Subject: Re: [EXTERNAL] Re: Preliminary ROC on LTO plots to start discussion

been applied as a constant for each day with some inter-day randomness added in? Please advise.
Regards,
Vamsi
On Thu, May 9, 2019 at 2:33 PM Perry, Russell < reperry@usgs.gov > wrote:
Hi Cathy,
Find attached three pdfs one each for survival, median travel time, and migration routing from Freeport to Chipps Island. Each page is a water year showing flows, DCC operations, and survival, travel time, and routing for PA and COS. So there's 82 pages in each pdf. We'll summarize this down into box plots, but I think these are a good place to start understanding how operations change both within and among years and how that affects daily survival, travel time, and routing.
Vamsi,
Cathy asked if we could summarize the STARS runs that we did for the life cycle model to provide some further insights in the ROC on LTO effects analysis. I'd like to include you as a co-author on our report for for the work that you've done gathering the daily flow and DCC data and summarizing our investigations of using STARS for the life cycle model.

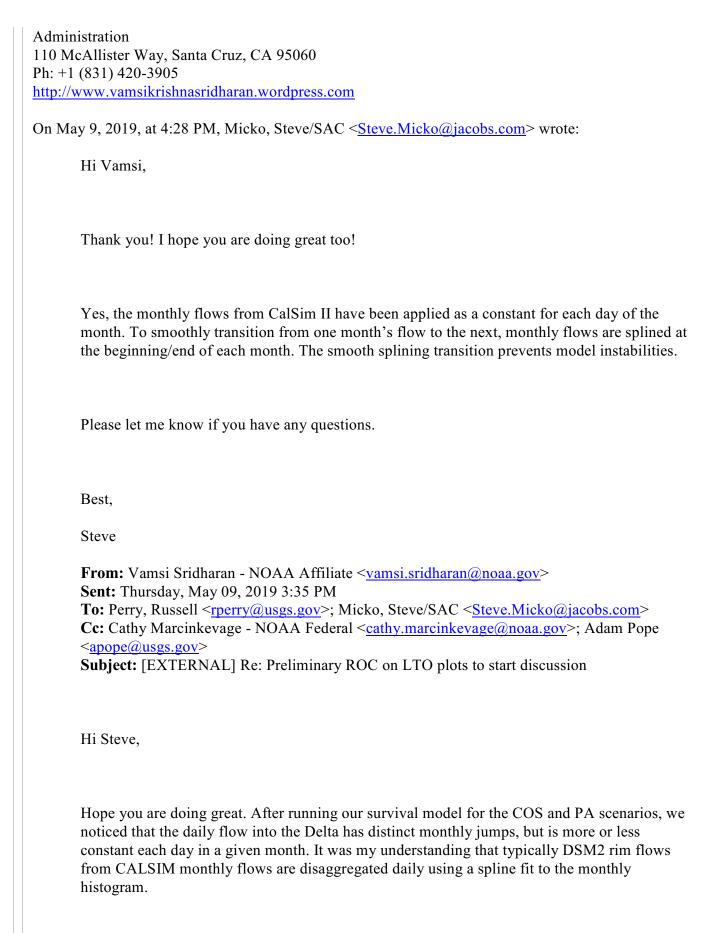
Given what Steve said about the flow disaggregation, I think we should have a note in the final report that explains this. Otherwise, there would be potential for misinterpretation of these results that there is somehow some monthly step function response of the system, and of the fish's movements.

All,
The flow data changes daily, but does have obvious monthly "jumps", which seems quite different the from CALSIM daily dissaggregated flow data we used for WaterFix. Is this a characteristic that you've noticed before with these runs?
Are we just focused on COS and PA, or do we want to do anything with WOA?
These are hot off the presses and we haven't had a chance to absorb them yet, so let me know if you see anything wonky.

We can include the note easily. If Russ and Adam don't have it in their reporting out, we can be sure to have it in the BiOp writeup.
